Errata A117.1 Chapter 3 – Building Blocks

Standard: 2017 A117.1 Standard for AccessibleFacilities

Applies to following Printings: 1st Printing

Figure 404.2.3.2(G)
MANEUVERING CLEARANCE AT MANUAL SWINGING DOORS
LATCH APPROACH – PULL SIDE

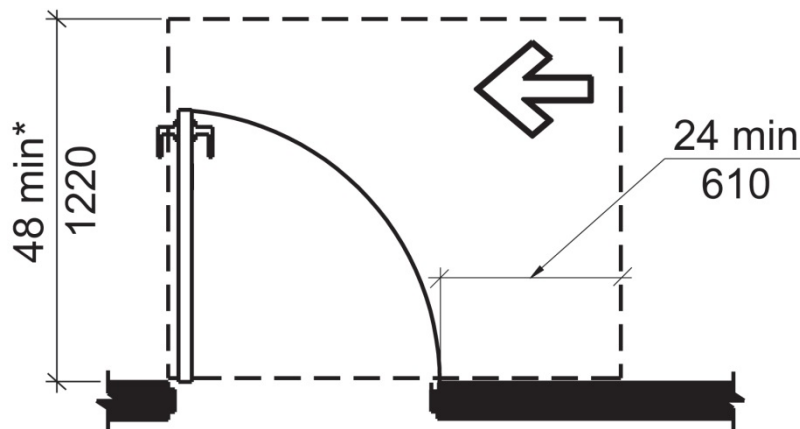
The second 'if' is changed to 'is' in the asterisk note.

*54 min (1370) if closer is provided

FIGURE 607.4.1(A)
GRAB BARS FOR BATHTUBS WITH SEAT AT HEAD END OF TUB - ELEVATION

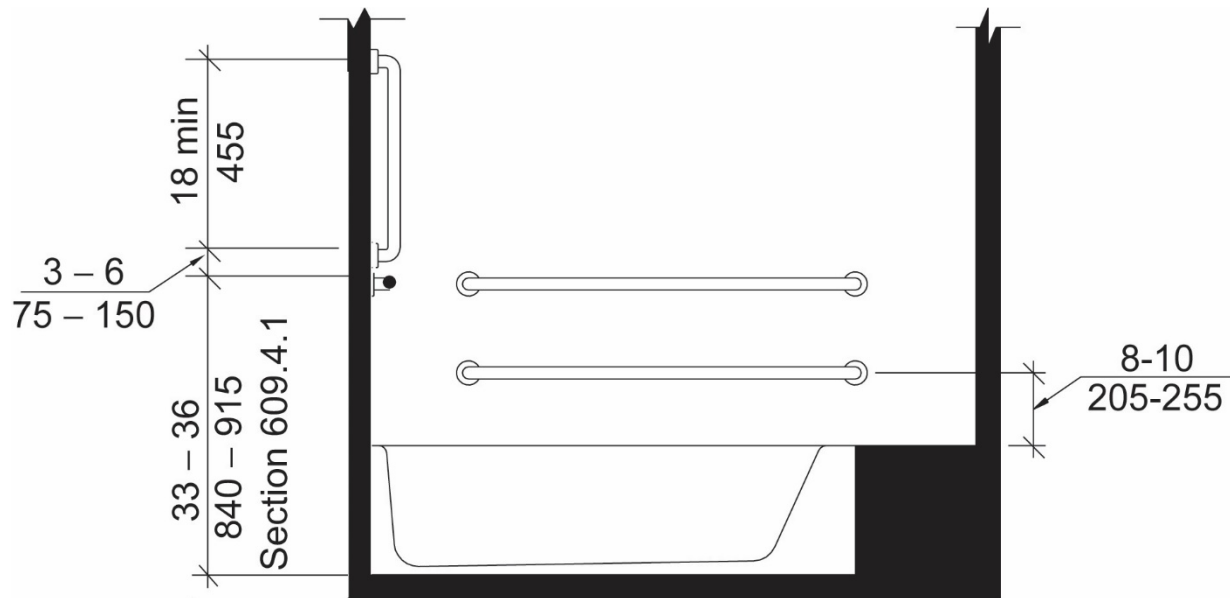
The base of the line indicating the location of the 33-36 inch measurement has been raised to the top of the floor beneath the tub.

Section/Table/Figure Number: Figure 607.4.2(A)

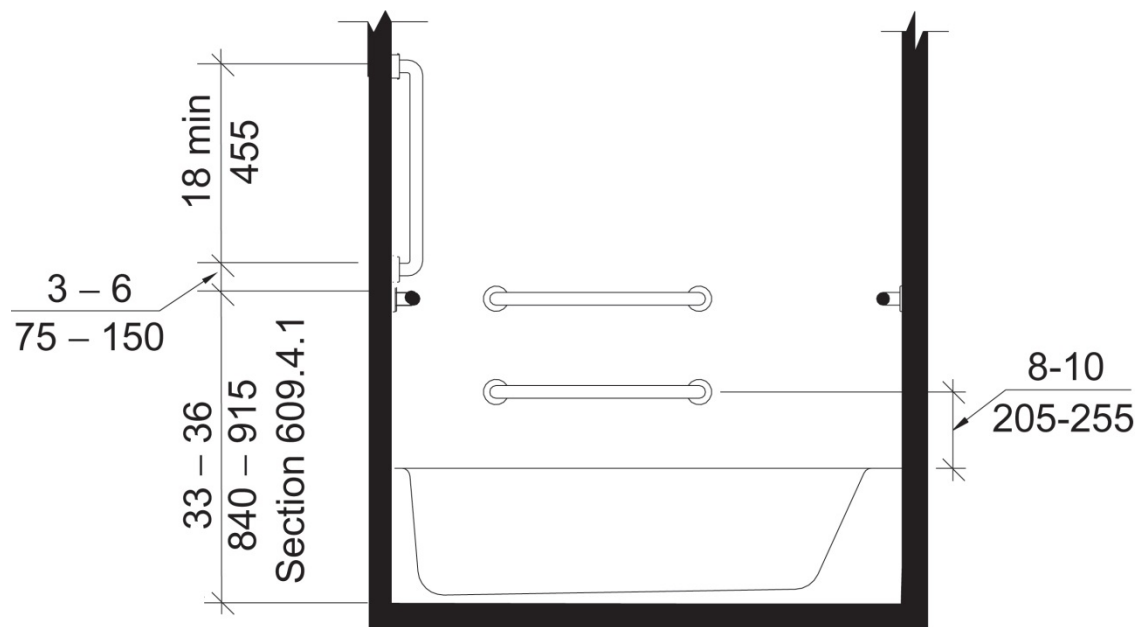
The base of the line indicating the location of the 33-36 inch measurement has been raised to the top of the floor beneath the tub.

Section/Table Number: Figure 608.2.1.1

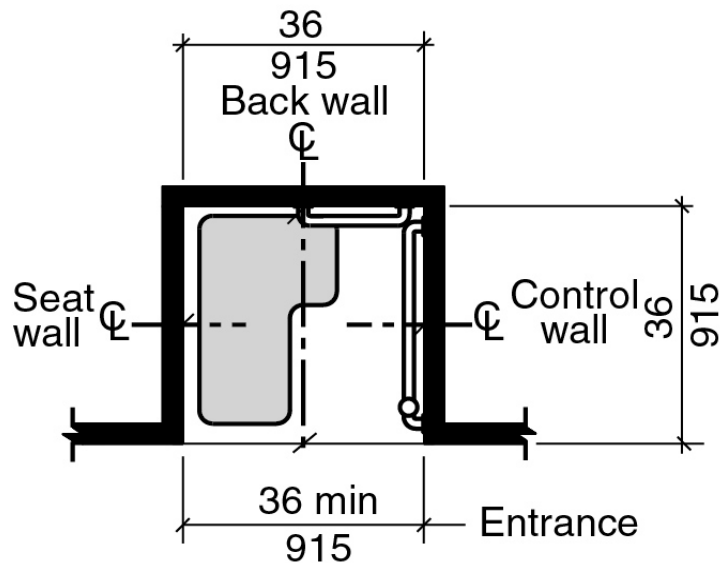
In 2 places '36 min' to just 36. (At the very top and the far right side of the figure.

Corrected figure is below

FIGURE 608.3.1(A)
GRAB BARS IN TRANSFER-TYPE SHOWER – ELEVATION

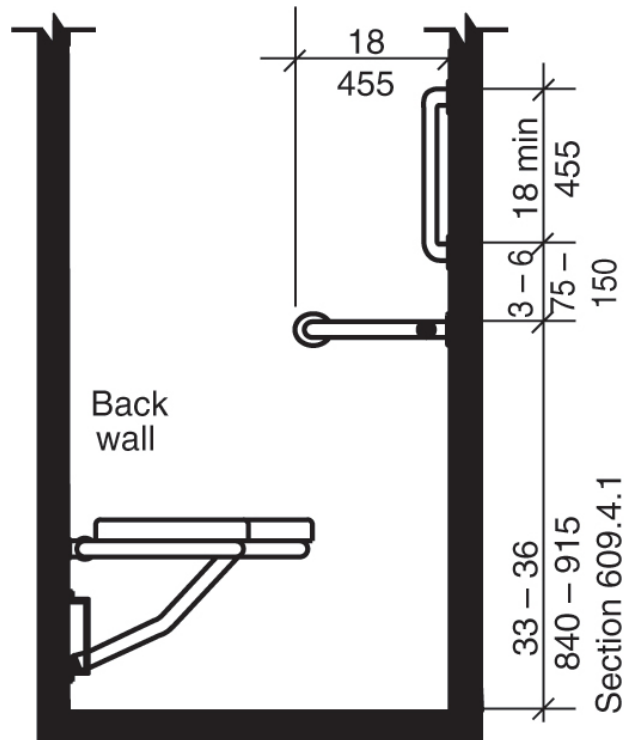
The base of the line indicating the location of the 33-36 inch measurement has been raised to the top of the floor of the shower.

FIGURE 608.3.2(A)
GRAB BARS IN STANDARD ROLL-IN-TYPE SHOWER
ELEVATION

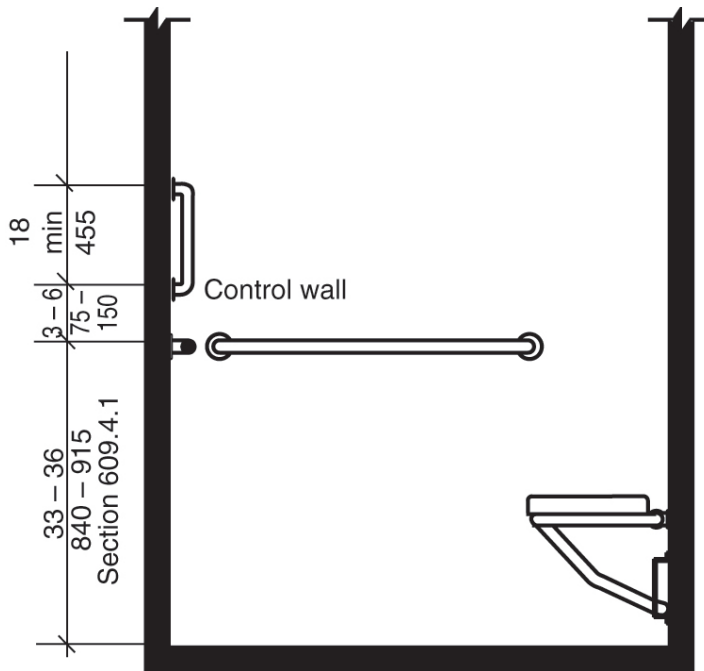
The base of the line indicating the location of the 33-36 inch measurement has been raised to the top of the floor of the shower.

**FIGURE 608.3.3(A)
GRAB BARS IN ALTERNATE ROLL-IN-TYPE SHOWER
ELEVATION**

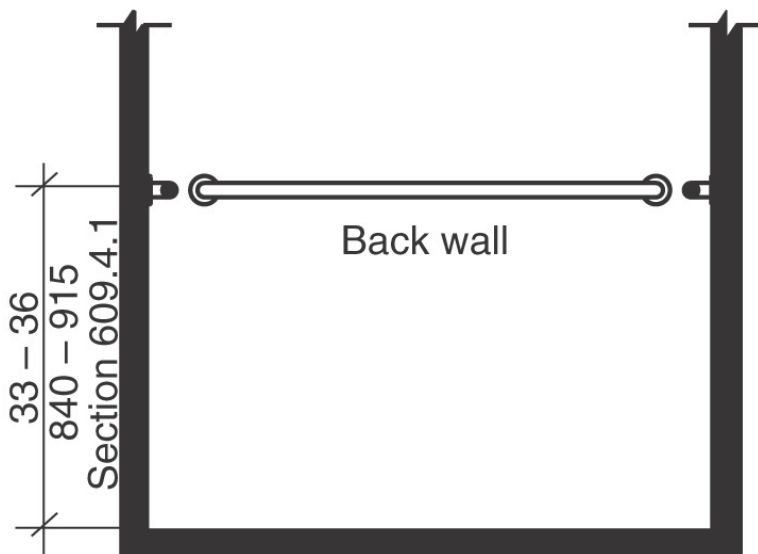
The abbreviation 'max' is removed from the 33-36 measurement.

**FIGURE 609.3
SPACING OF GRAB BARS**

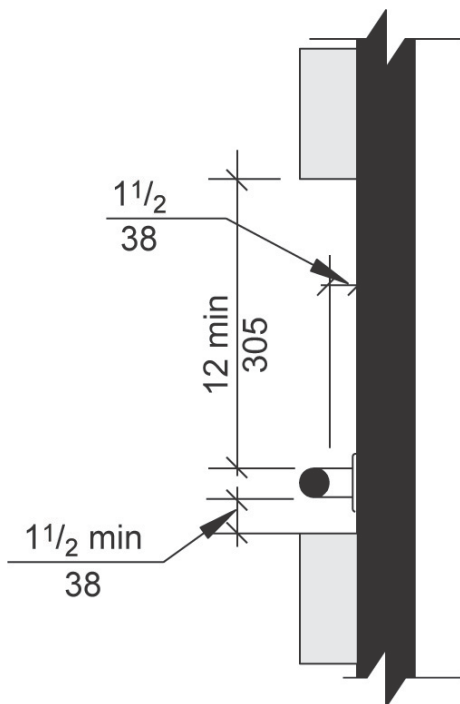
The abbreviation 'min' has been removed from the 1-1/2 inch measurement between the grab bar and the wall.

FIGURE 904.3(B)
SALES AND SERVICE COUNTERS - ELEVATION

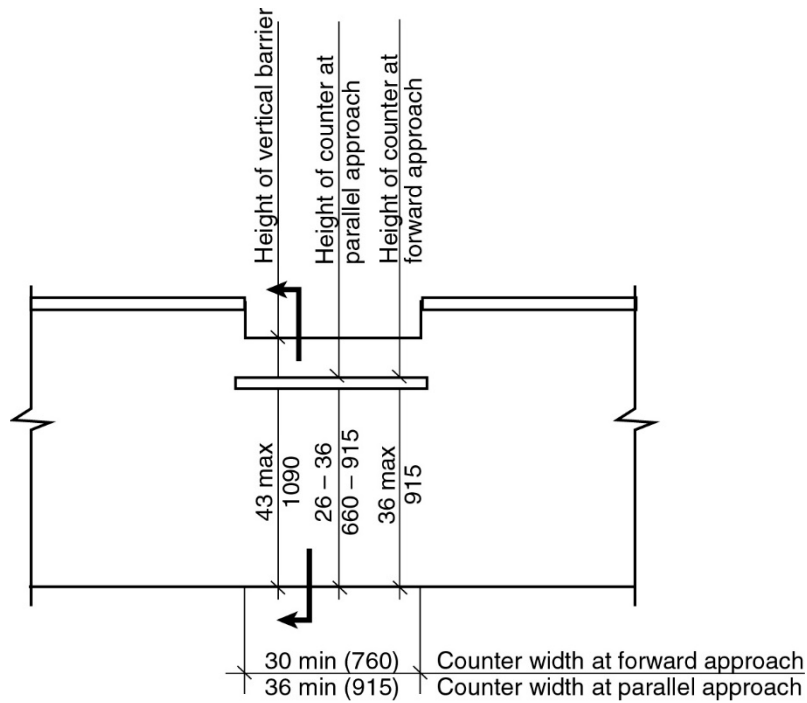
Figure is corrected to show **minimum counter width** for both forward and parallel approaches

Figure Number: Section 1103.12.1.2 (B)

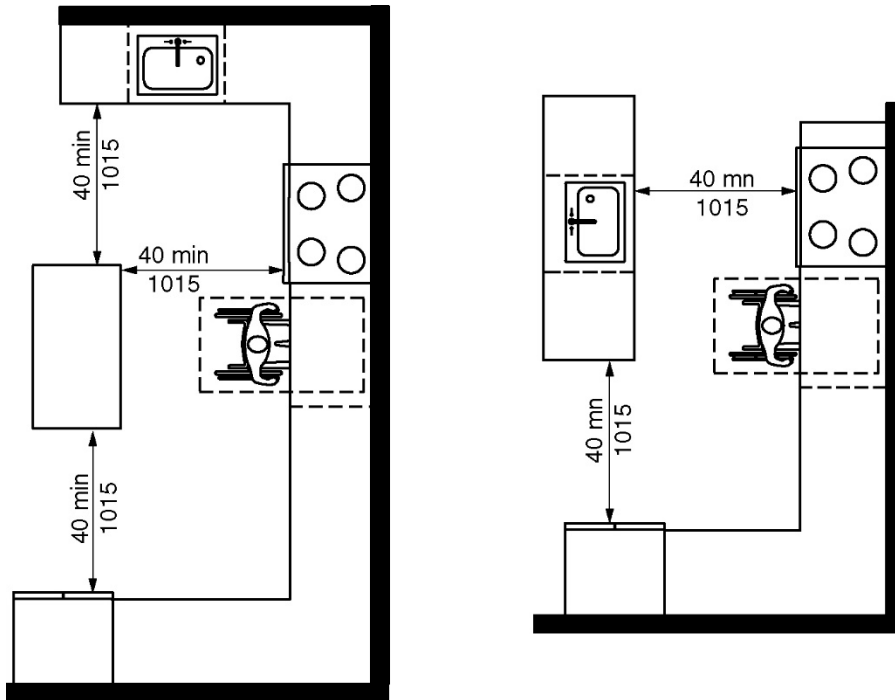
Replace Figure 1103.12.1.2(B) as follows:
